FORD 4R100 "UPDATE HANDBOOK"

FORD 4R100 "UPDATE HANDBOOK"

Since the introduction of the 4R100 transmission in model year 1998, there have been many engineering changes to improve Pleaseability, Reliability and Durability concerns. These changes have affected most every part used in this transmission. This "Update Handbook" will explain each change, the reason for the change, and any parts interchangeability concerns created by the change, along with any part numbers needed to update your transmission.

Figure 73

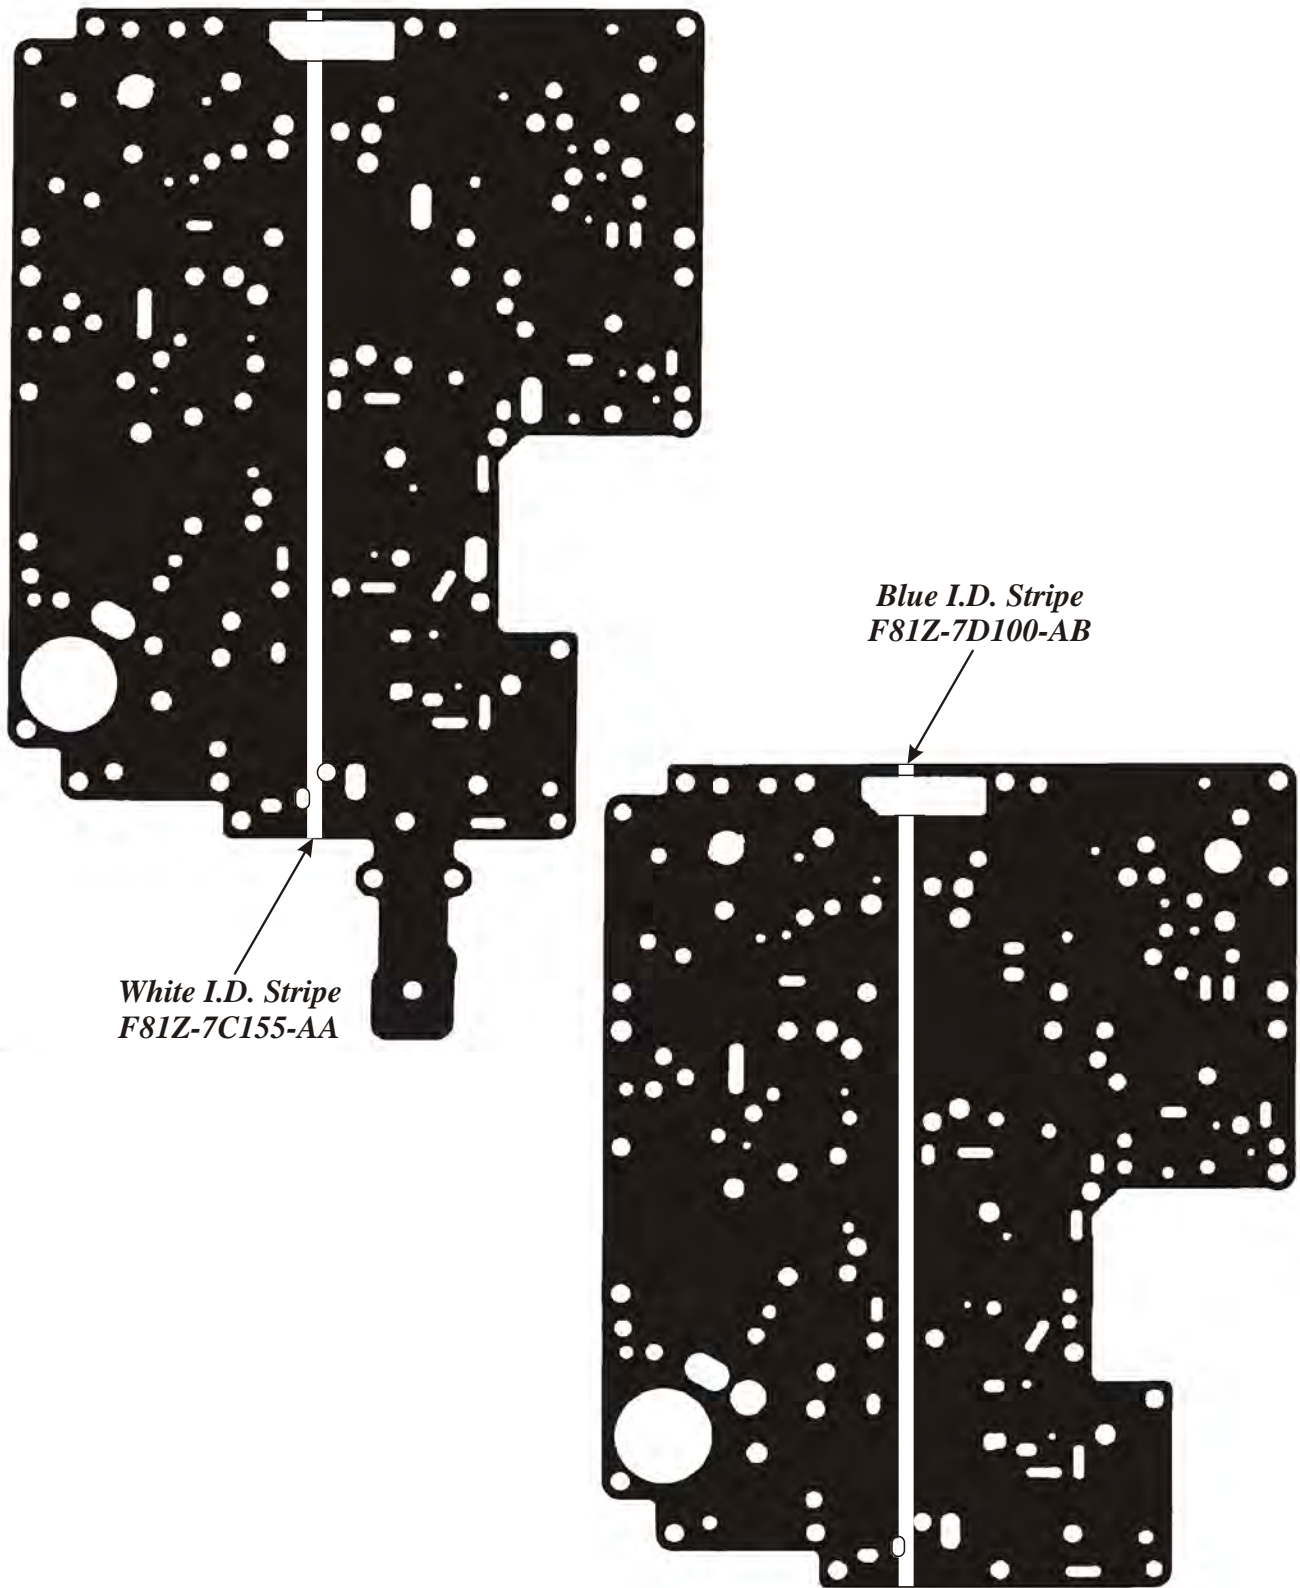
- (1) SPACER PLATE - Ford Motor Co. part number F81Z-7A008-EA or F8UZ-7A008-CA, as shown in Figure 72.
- (2) CASE TO SPACER PLATE GASKET - Ford Motor Co. part number F81Z-7C155-AA, with "White" stripe for identification, as shown in Figure 73.

- (3) SPACER PLATE TO V.B. GASKET - Ford Motor Co. part number F81Z-7D100-AB, with "Blue" stripe for identification, as shown in Figure 73.
- (4) COOLER BYPASS ASSEMBLY - Ford Motor Co. part number F81Z-7H322-AA for 1996 models only, as shown in Figure 74. 1997 and 1998 models came with cooler bypass.

Figure 78

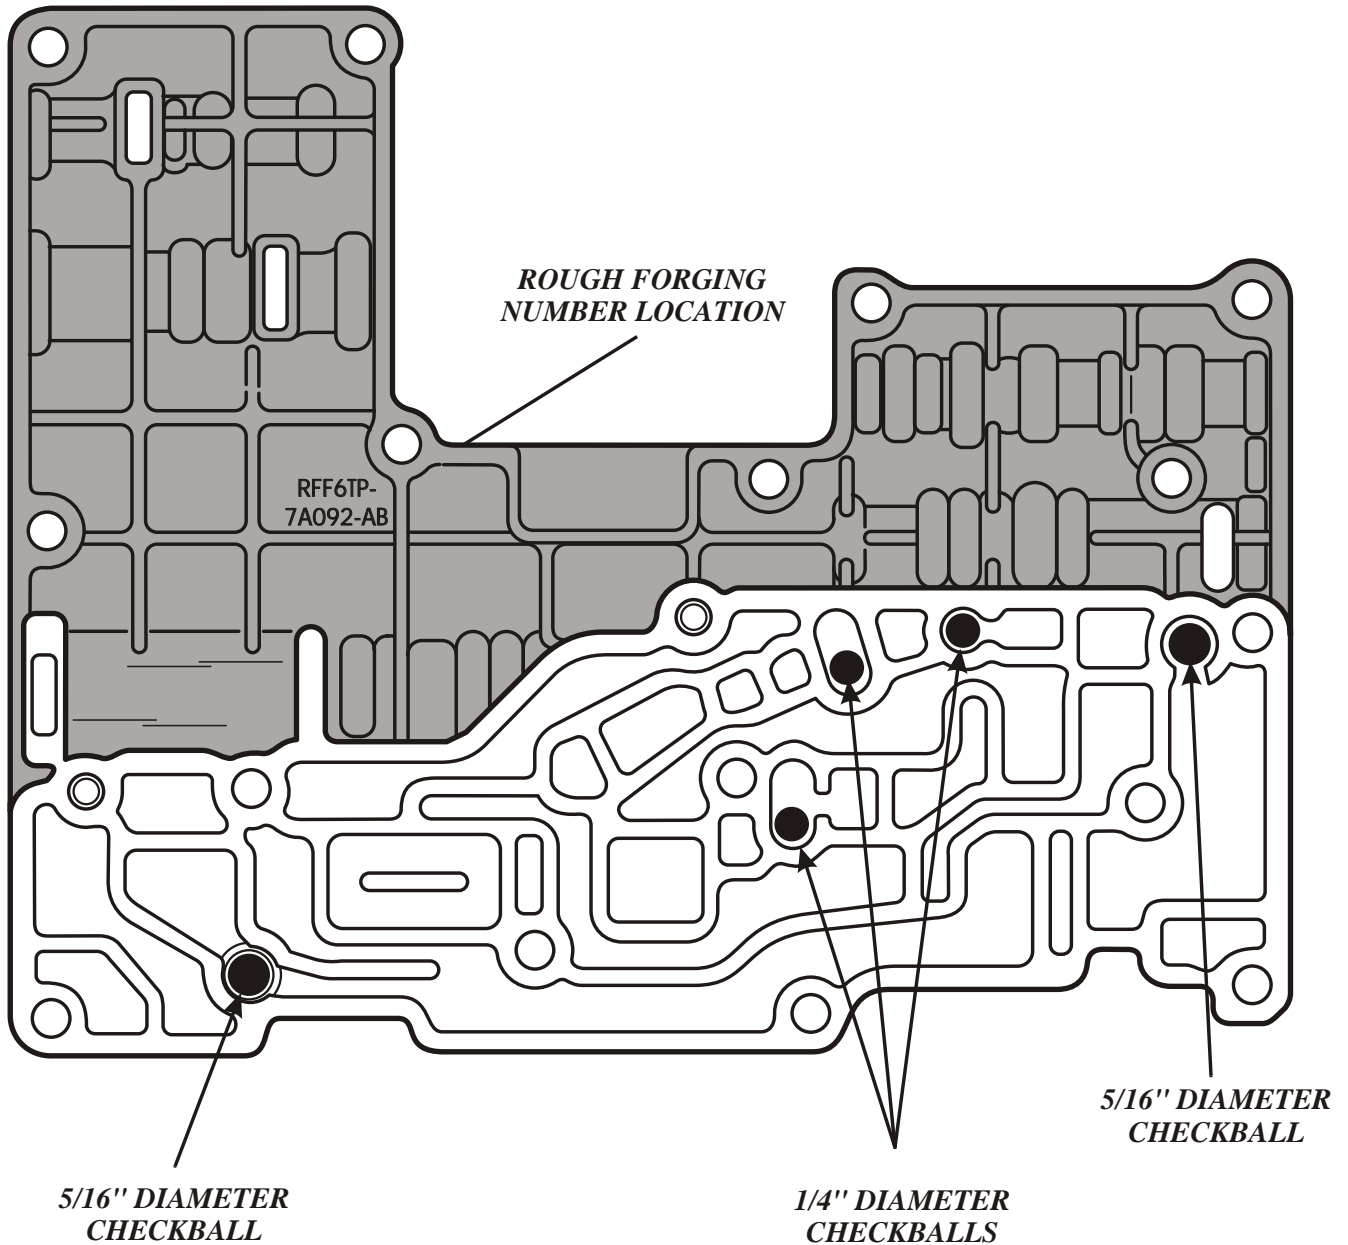
- (7) EXTENSION HOUSING - A4R100 style with boss in the extension housing to retain the lube plug in the new design case, as shown in Figure 76.
- (8) MAIN VALVE BODY - Requires 1996 hydraulics which is identified by RF-F6 cast into the valve body, in location shown in Figure 77, and checkball locations are shown in Figure 78.

VALVE BODY CHECKBALL LOCATIONS
REQUIRES THREE 1/4" RUBBER BALLS,
AND TWO 5/16" RUBBER BALLS

Figure 79

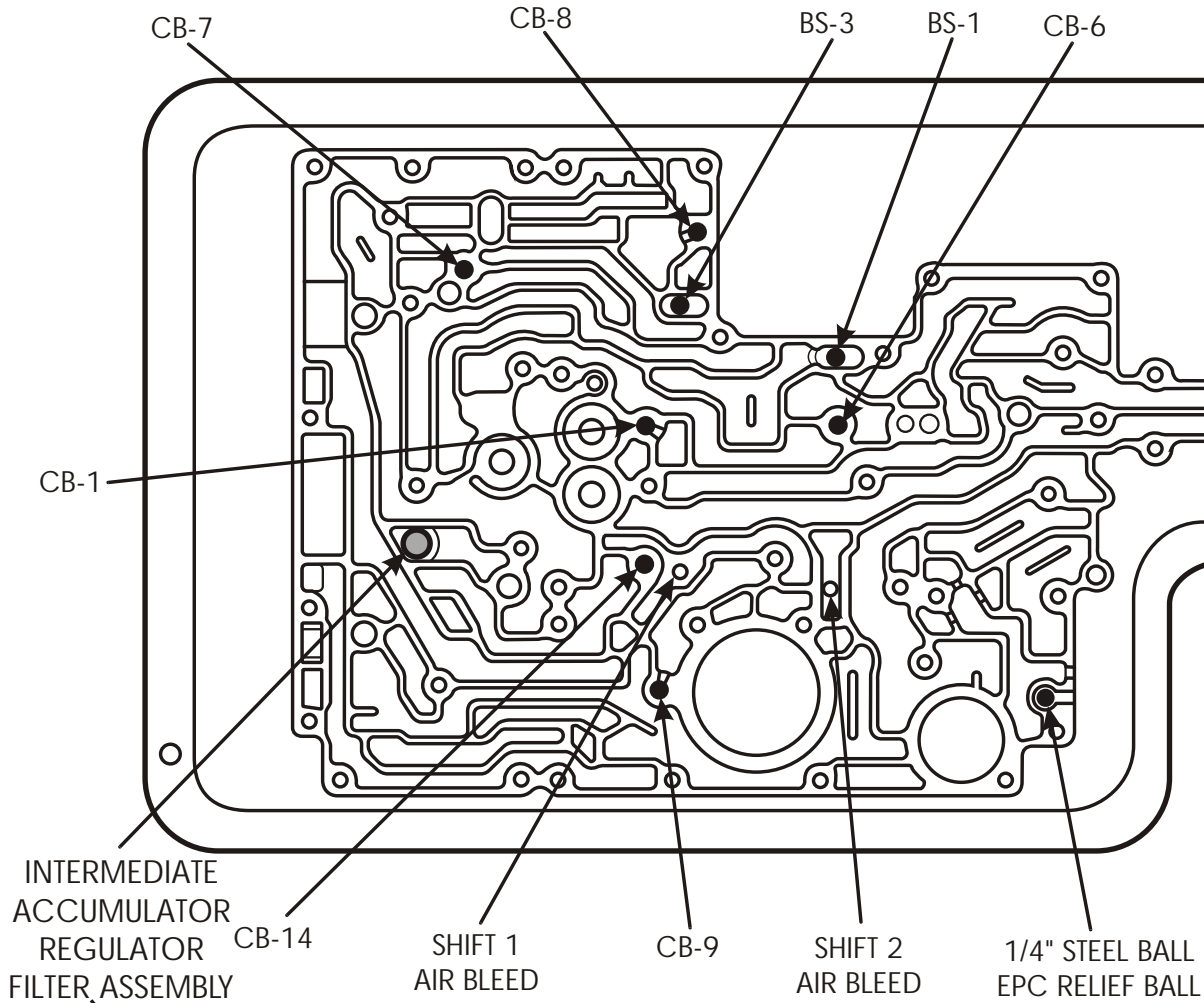
- (12) CASE CHECKBALL LOCATIONS - Requires the 1996 and later case checkball locations, which is eight checkballs in locations shown in Figure 79.

4R100 "MODIFIED" CASE CHECKBALL LOCATIONS REQUIRES EIGHT (5/16") RUBBER BALLS

Figure 2

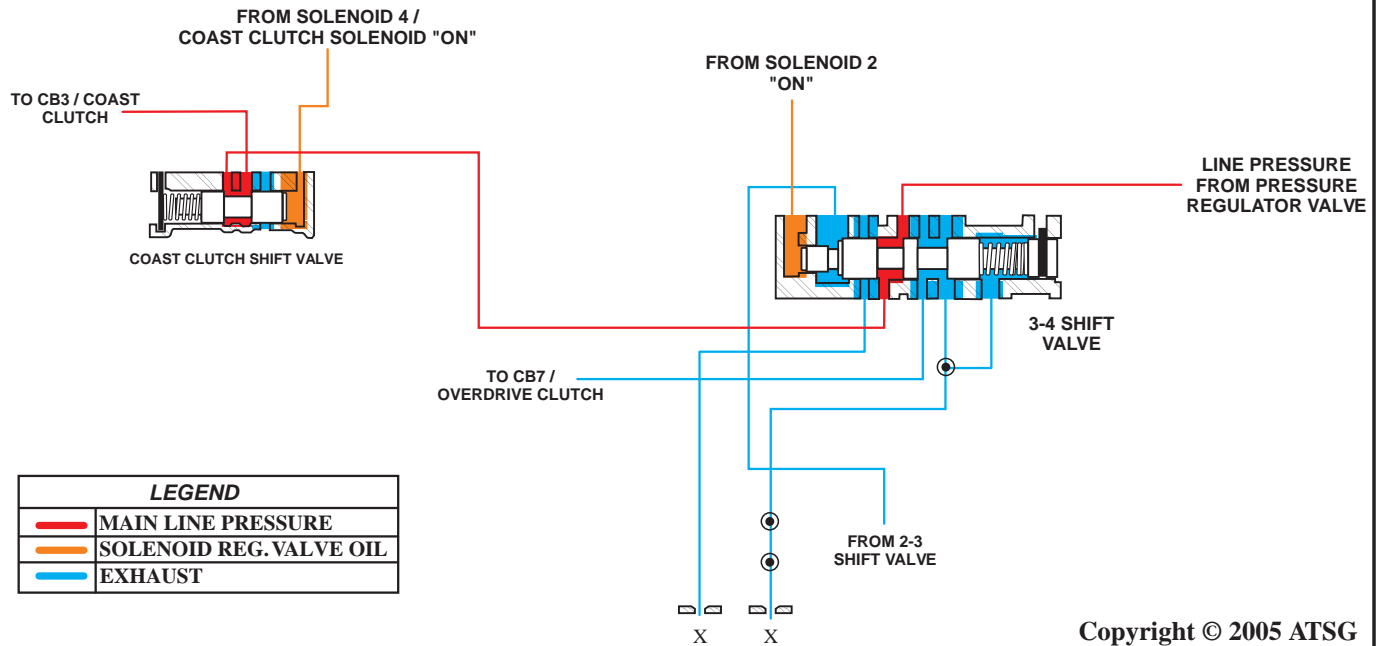
All of this happened within a few seconds. In Figure 2 we have provided a partial hydraulic circuit diagram to show some of the hydraulic changes that had to be made to the 3-4 shift valve and why these changes were necessary. As you can see, the 3-4 shift valve is now connected to line pressure
